**PD Modification Application: MM 25-1372**

**Zoning Hearing Master Date:** February 23, 2026

The Applicant requests a major modification to the existing Planned Development (PD 83-0173, as most recently modified by PRS 08-1298) for a 50.01-acre property at 6302 E. Dr. Martin Luther King Jr. Blvd. in the East Lake Orient Park Community Plan Area. The PD is currently approved for Commercial Office use, this will be retained as Option A. The proposed modification adds All M uses except Heavy Industrial as Option B. The change allows up to 588,490 sf of industrial space (F.A.R. 0.27) and updates to site development standards.

2.5.1 Proposed Site Plan (partial provided below for size and orientation purposes. See Section 8.2 for full site plan)

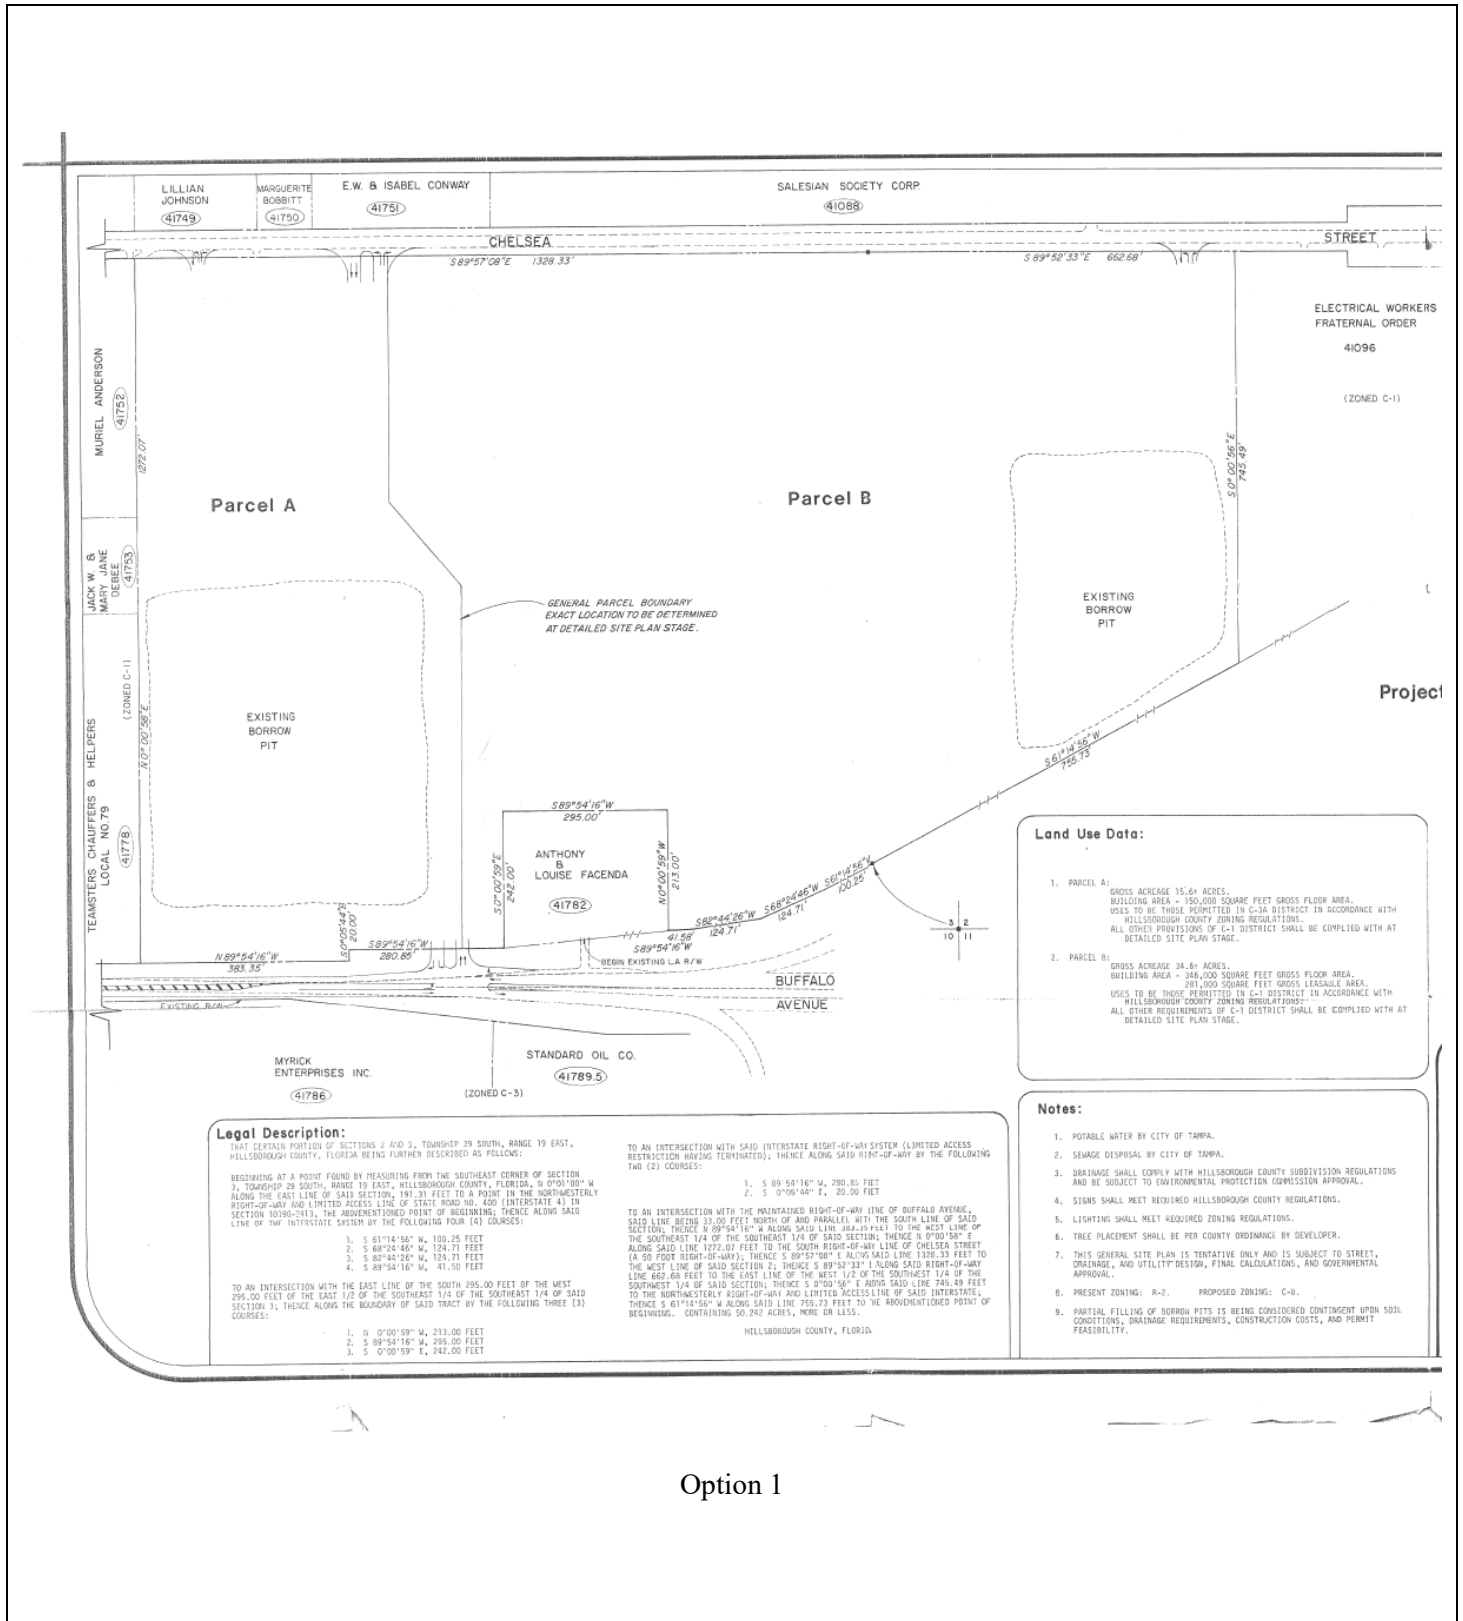
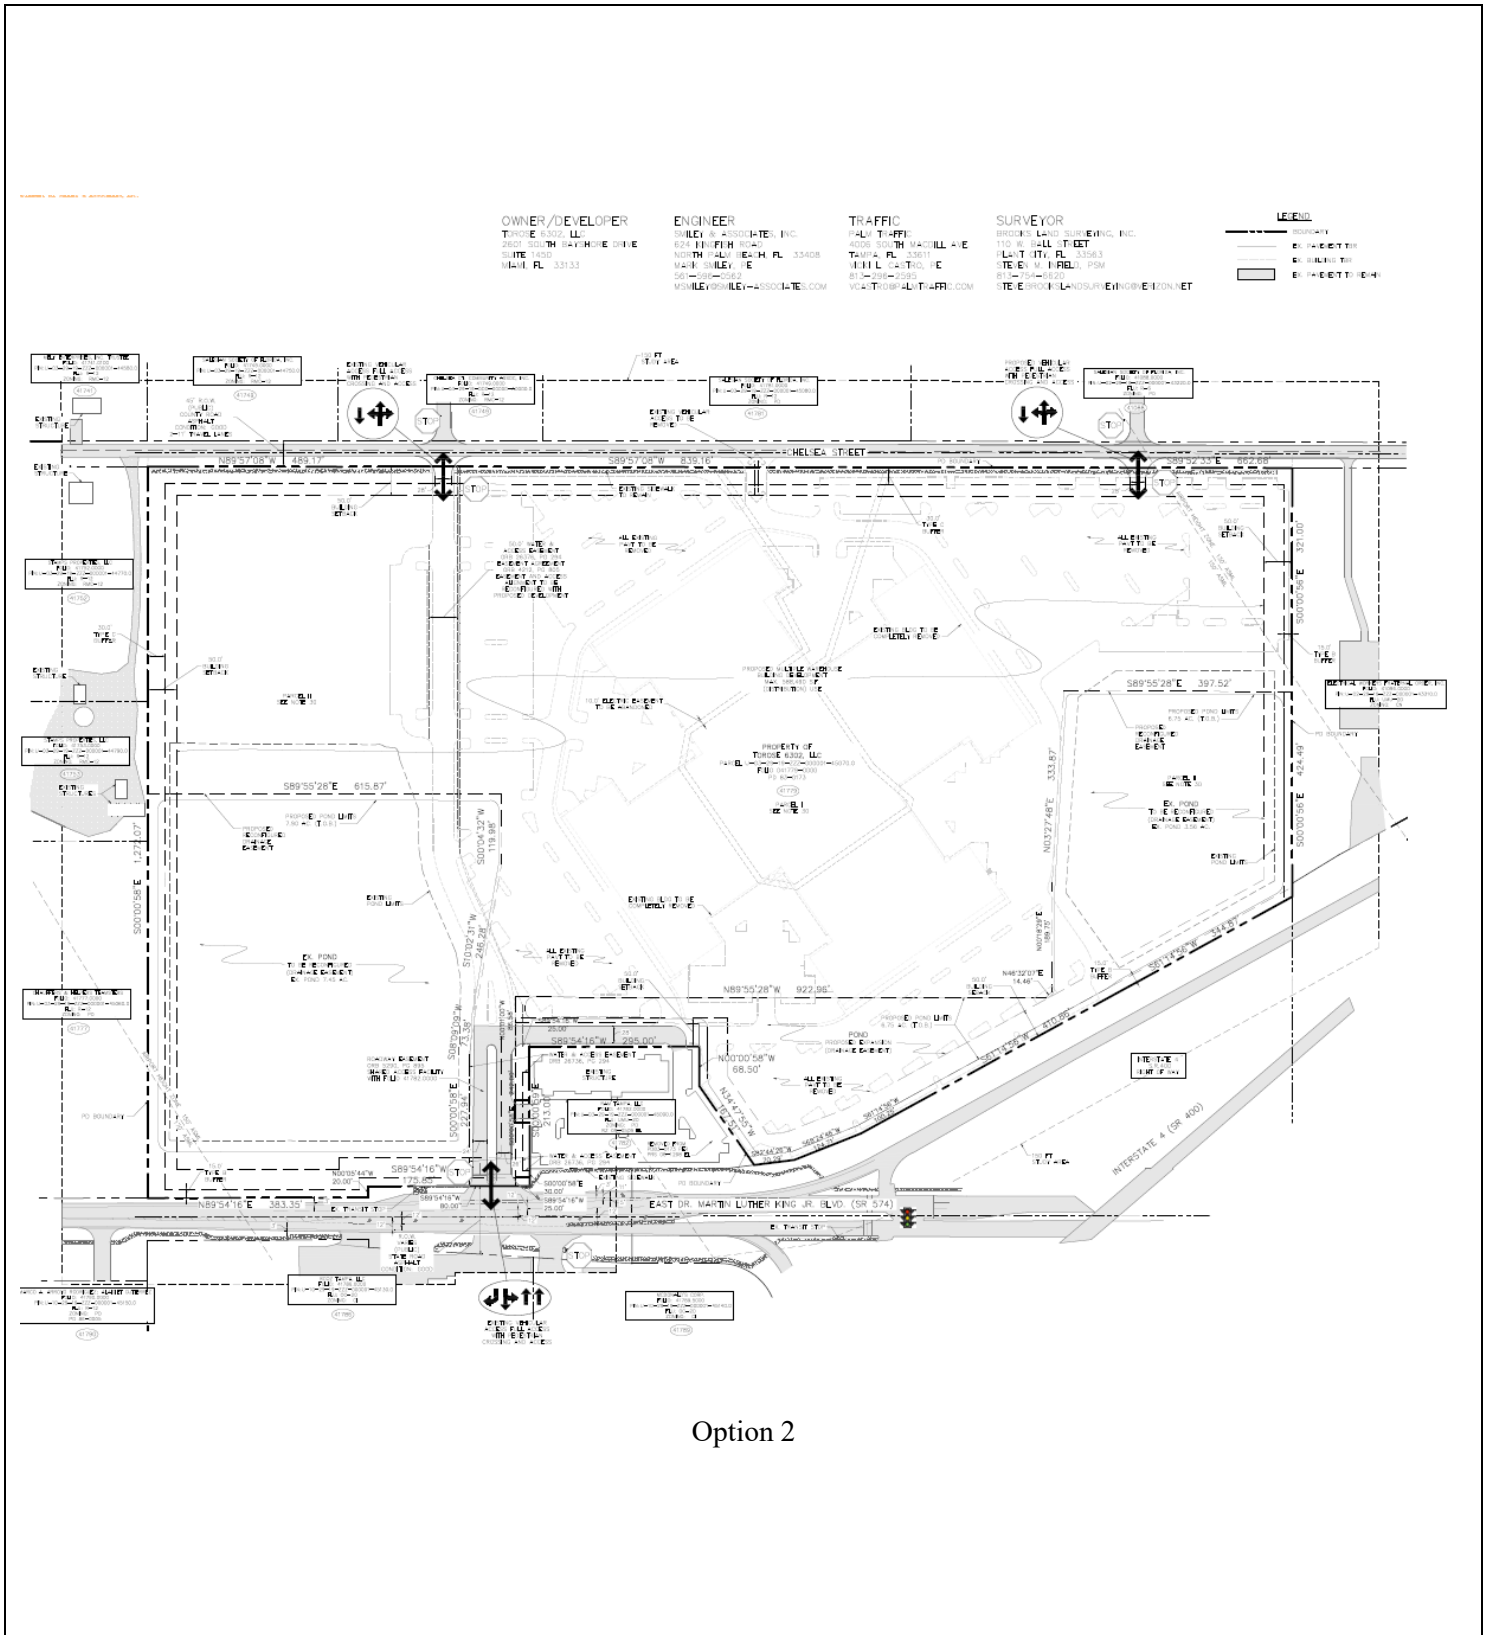
Prior to certification, the applicant shall make the following revisions to the PD site plan:

1. Indicate a 15'/B buffer and screening towards the hotel to the south.
2. Revise the proposed property use for Option B to all M uses except Heavy Industrial.
3. Update all references to Buffalo Avenue in the site plans to reflect the current designation as Martin Luther King Jr. Boulevard.

REVISION DATE: 10/17	TRANSPORTATION TECHNICAL MANUAL	 Hillsborough County Florida	LOCAL URBAN ROADS (2 LANE UNDIVIDED) TYPICAL SECTION	DRAWING NO. <b>TS-3</b>
				SHEET NO. 1 OF 1

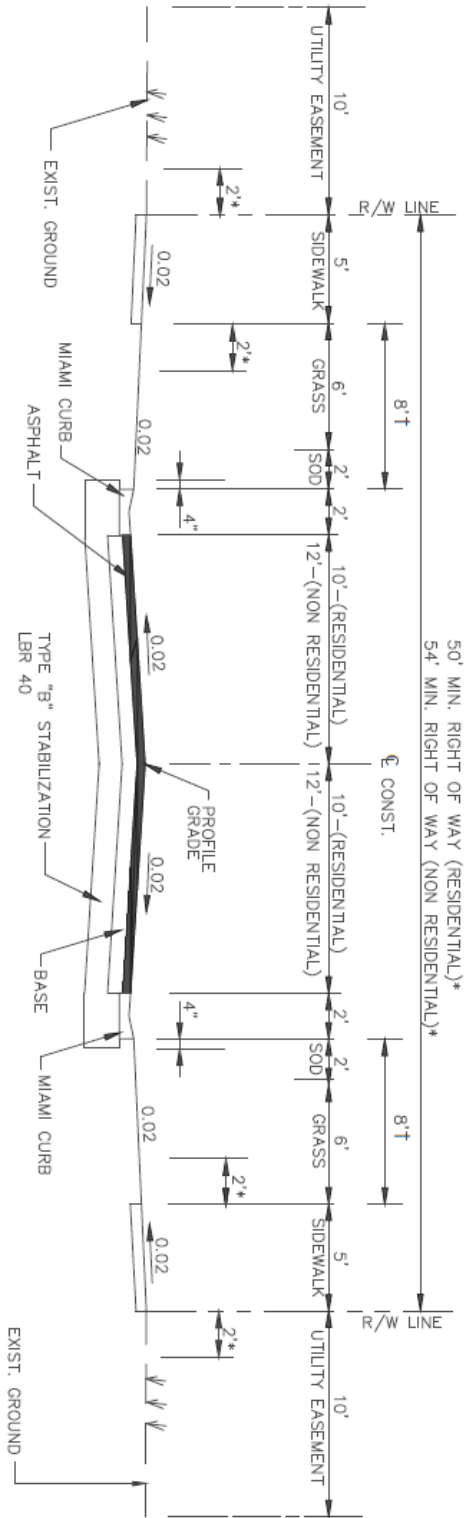
1. The request is to maintain the existing 11-foot travel lanes instead of the 12-foot travel lanes. According to the Florida Green Book, on a suburban roadway where the speed limit is between 40 and 45 mph, 11-foot travel lanes may be used. The posted speed limit on Chelsea Street is 40 mph.
2. The TS-3 incorporates a Miami type curb. Given this section of Chelsea Street does not have a Miami type curb within the immediate area, it is requested to maintain the existing section without a Miami type curb.

- 3. The TS-3 section has an 8-foot grass strip between the sidewalk and the curb. The request is to provide an 8-foot grass strip where possible, but given existing conditions, there may be locations where the grass strip is reduced for limited areas.
- 4. The TS-3 section includes a 5-foot sidewalk on both sides of the roadway. The request is to provide approximately 2,400 feet of 5-foot sidewalk on the south side of the roadway from N. 56<sup>th</sup> Street to the western property line. The property frontage already has approximately 2,000 feet of sidewalk along the south side of Chelsea Street.
- 5. The TS-3 includes a utility easement outside the right-of-way. Given that the developer does not own the land, the request is not to provide the 10-foot utility easement.
